[Tech Alert 194](#)

OICB-15B-7HM7U When Mounted in a Panel Powers Off Intermittently

Topic#: 002891

FIGURE: TORQUE SPECIFICATIONS

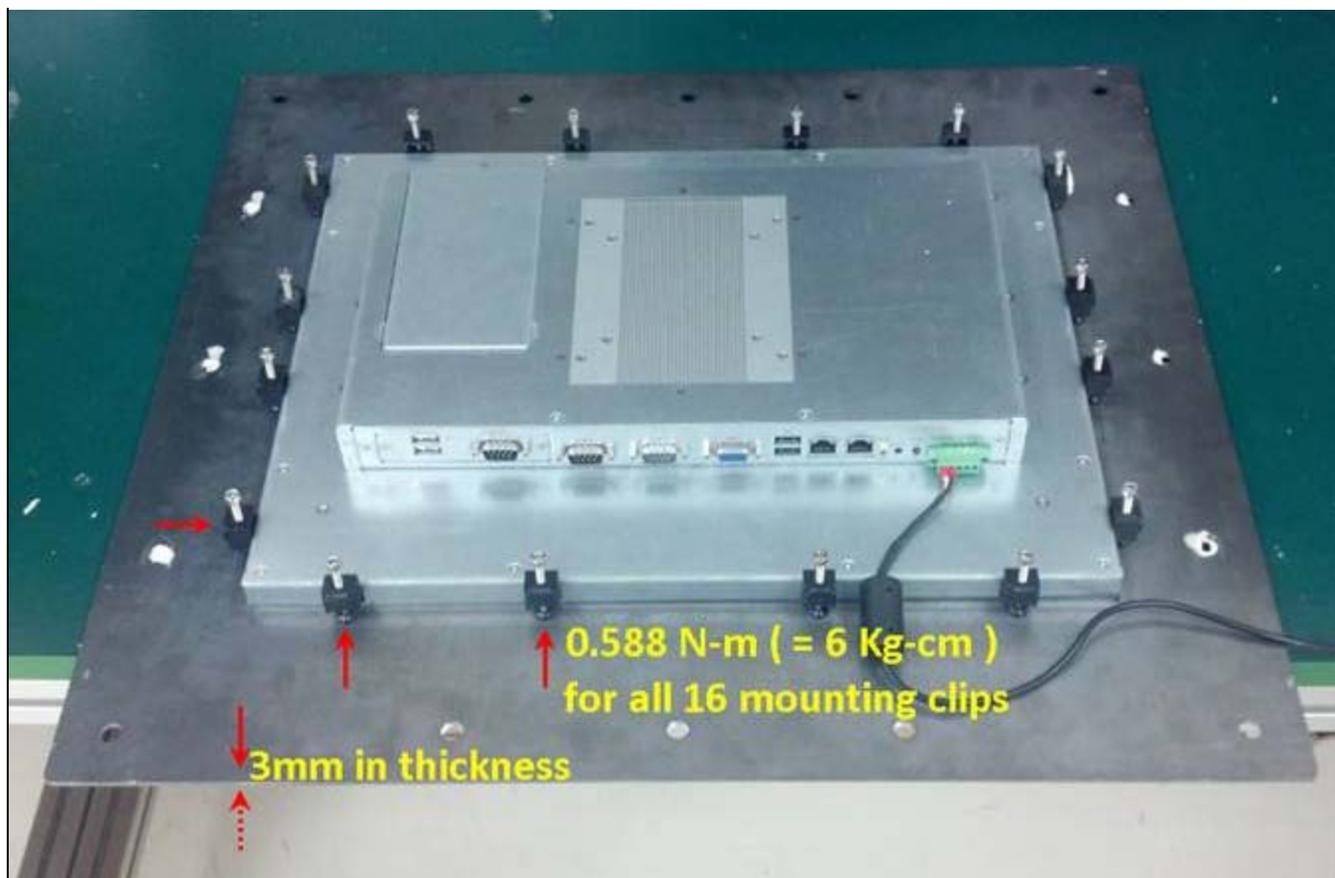
The red arrows in the figure below indicate the mounting screws located directly behind the front power switch. If these screws are secured too tightly, the heavy torque causes the power connector inside the front bezel to be easily engaged when there is movement or vibration. The activation of the power switch can cause the unit to be powered off.

The correct torque value for the mounting screws is ~ **0.59 N-m** (around 6 Kg-cm). This allowable torque value supersedes the higher torque value specified in the documentation.
